Cortina Systems[®] LXT971A, LXT972A, LXT972M Single-Port 10/100 Mbps PHY Transceivers

Specification Update

Document Number 249354

Revision 13.0

Item 15: Detection of Illegal Symbols After SSD

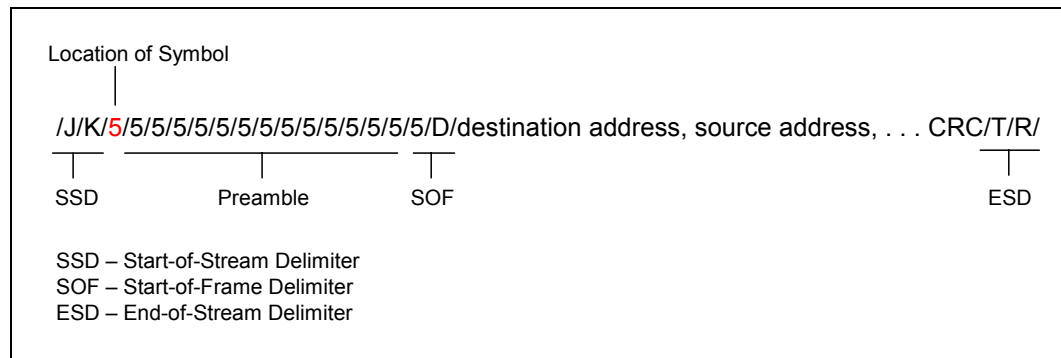
Problem An illegal symbol placed immediately after the SSD (preamble after JK) is not detected. However, any subsequent corrupt symbol will be detected.

Implication RXER does not assert if this symbol location is corrupted. However, an error in this location does not affect packet integrity.

Workaround Use the MAC layer protocol to detect corrupt symbols in the packet.

Figure 10 Ordering Information Matrix - Sample

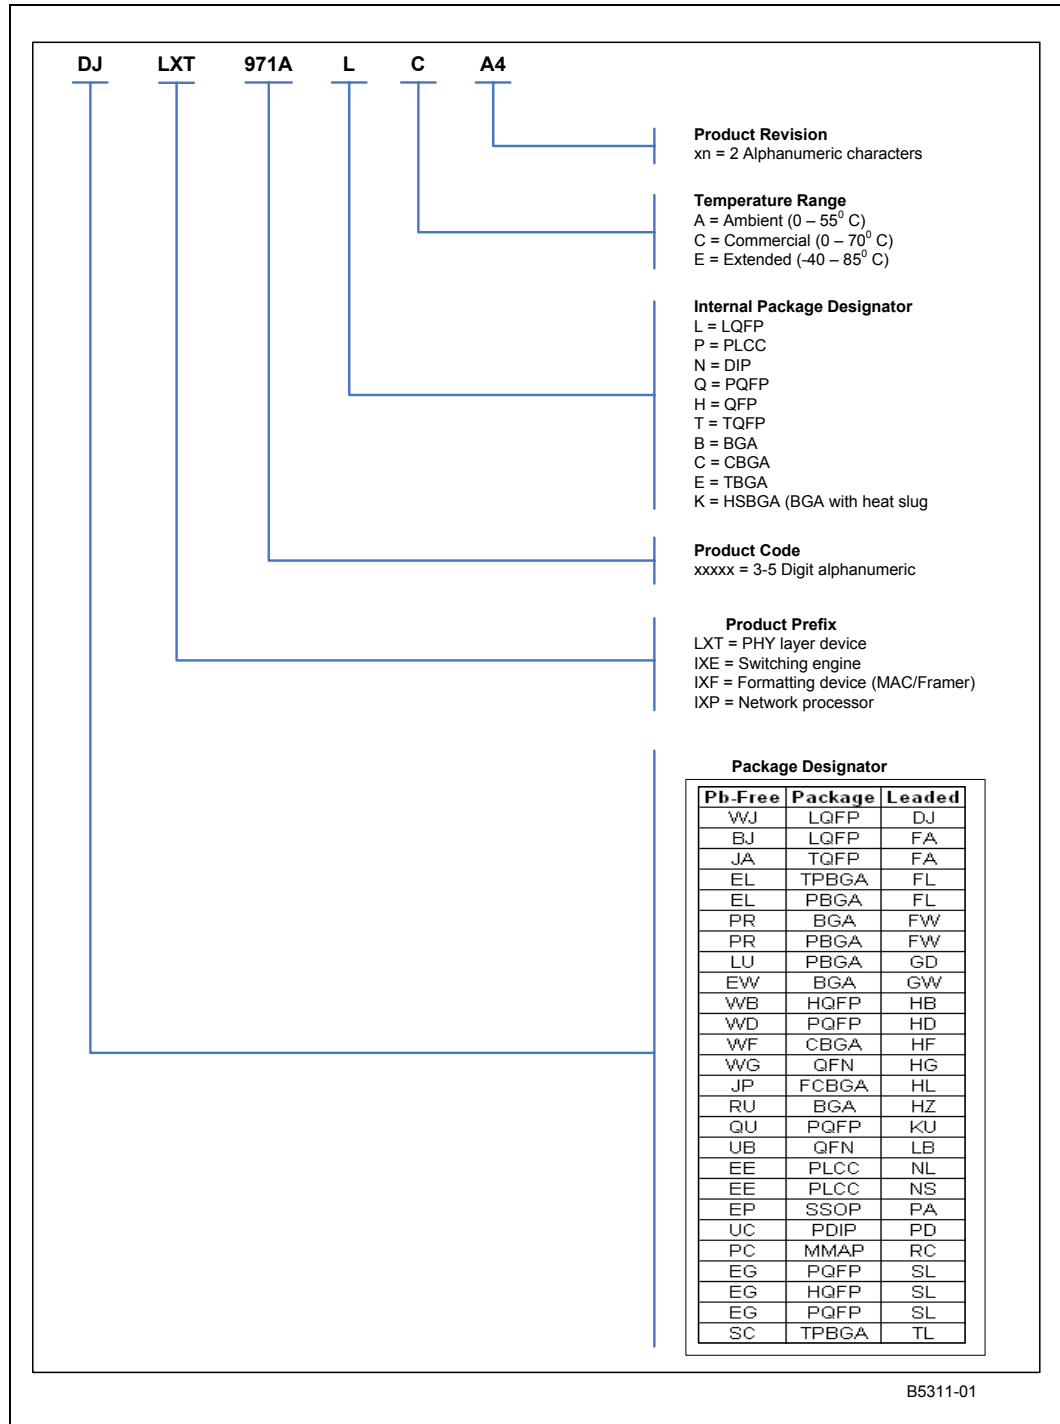
Change 2. The ordering information matrix changes as shown in [Figure 10](#).
